Service Information

# Model: Finisher-E1

# **Ref. No. :** FF-T01-W-000137-02 **Date :** July 12, 2001

- Subject: To prevent 0081 jam due to the stack delivery belt overrunning
- **Reason:** Due to loose tension of the stack delivery belt, the stack delivery lever of the stack delivery belt overruns the home position sensor (S8), which may cause the 0081 jam. We will advise you on the corrective measure.

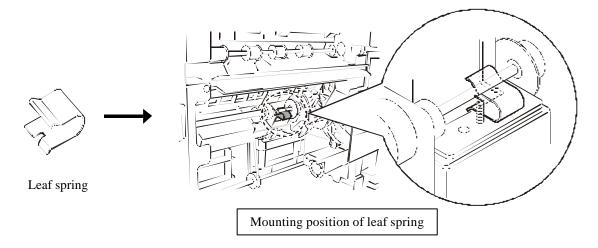
In case the before-mentioned symptom occurs, remove the right internal cover to mount a new part called leaf spring on the stack delivery pulley shaft.

- Temporary: Until a permanent measure is implemented, mount a new part, the leaf spring, on the stack delivery pulley shaft.
- Permanent: The shape of the stack delivery belt is changed in an attempt to prevent the belt from floating. Along with it, a type of the tension tight screw for the stack delivery belt is changed from a binding screw to a binding screw with a washer.
